SAFETY EVALUATION REPORT
FOR THE
BABCOCK AND WILCOX OWNERS GROUP
SMALL BREAK LOSS-OF-COOLANT ACCIDENT
EVALUATION MODEL, CRAFT2 (REV. 3)
(BAW-10092P, REV. 3 AND BAW-10154)

SAFETY EVALUATION REPORT
FOR THE
BABCOCK AND WILCOX OWNERS GROUP
SMALL BREAK LOSS-OF-COOLANT ACCIDENT
EVALUATION MODEL, CRAFT2 (REV. 3)
(BAW-10092P, REV. 3 AND BAW-10154)

Figure 2. Comparison of CRAFT2 to RELAP5.
RELAP5/MOD2 sensitivity study on percentage
of steam generator tubes wetted by AFW.

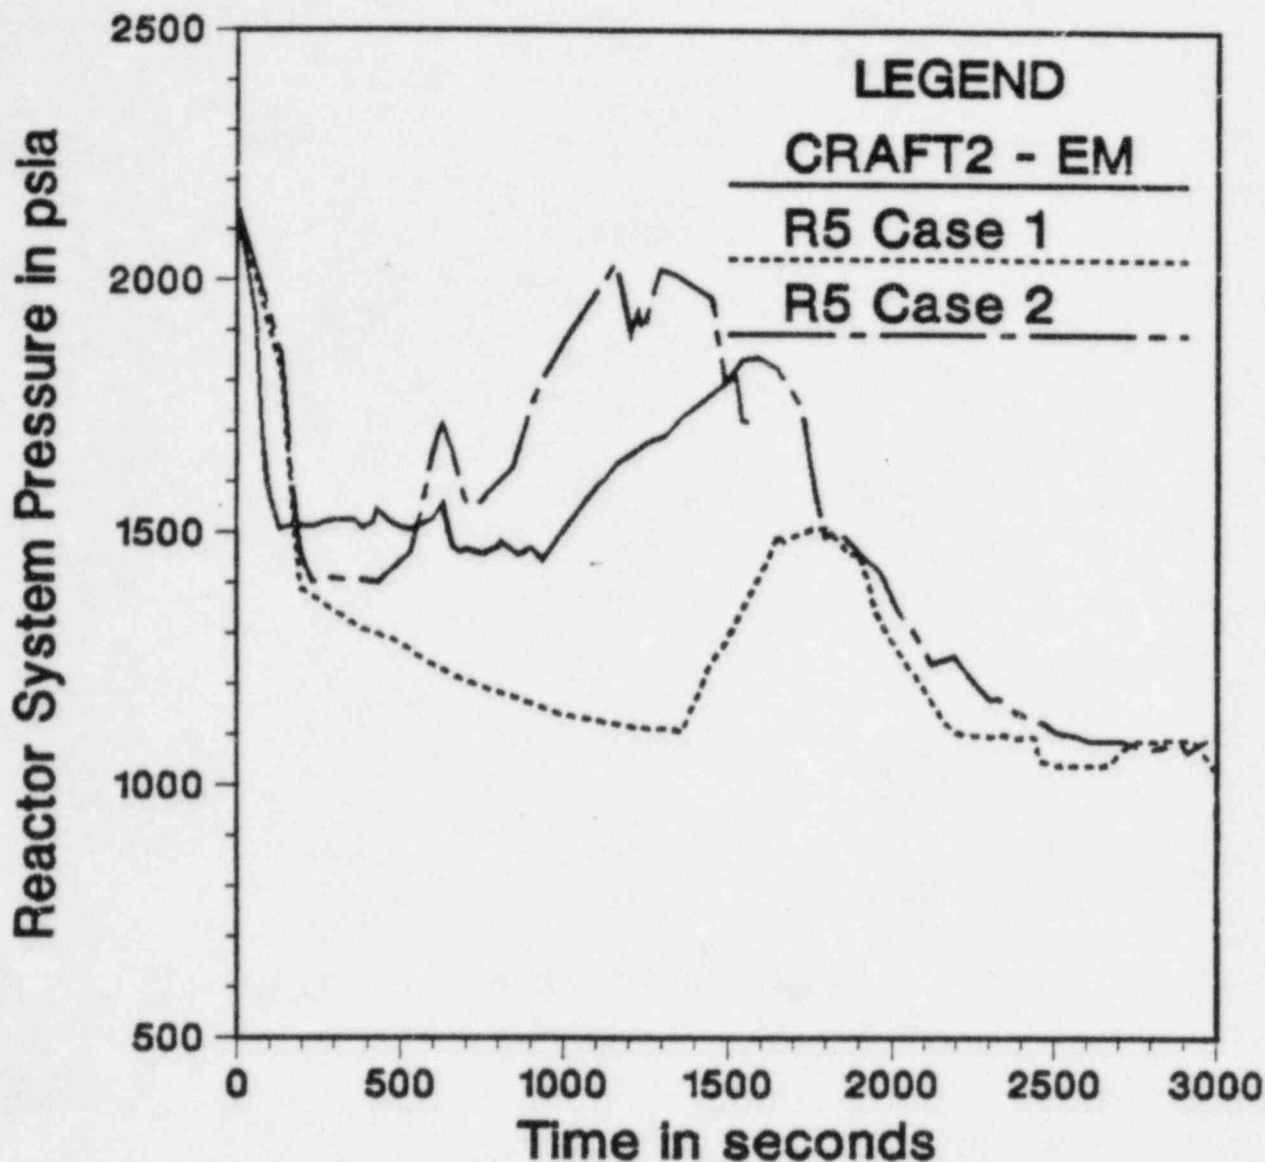
Recently completed analyses performed by the NRC with the RELAP5/MOD2 computer program have been qualitatively compared to the B&W CRAFT2 results for a 0.01 square feet cold-leg break (Reference 15). While this study was not intended to be a direct audit analysis, input assumptions were selected to explore the effects of natural circulation, reactor system repressurization, and boiler-condenser heat transfer including the effectiveness of Auxiliary Feedwater (AFW) spray on the upper OTSG tube elevations.

The RELAP5/MOD2 analyses indicated that although AFW wetting effectiveness can influence the primary system response, the general trends are unaffected. The analyses demonstrate that repressurization can occur during a small break LOCA at a B&W lowered-loop plant. Figure 2 provides a comparison of the RELAP5 results to a similar CRAFT2 analysis. This confirms the B&W CRAFT2 results for a similar size break. The timing of the operator action to raise the secondary system water level to 95% was found not to be critical. Some boiler-condenser heat transfer was found to occur with the level at 50% of the operating range, which terminated the increase in the reactor system pressure before the level was raised to 95%. Finally none of the conditions examined led to core uncover or heat-up.
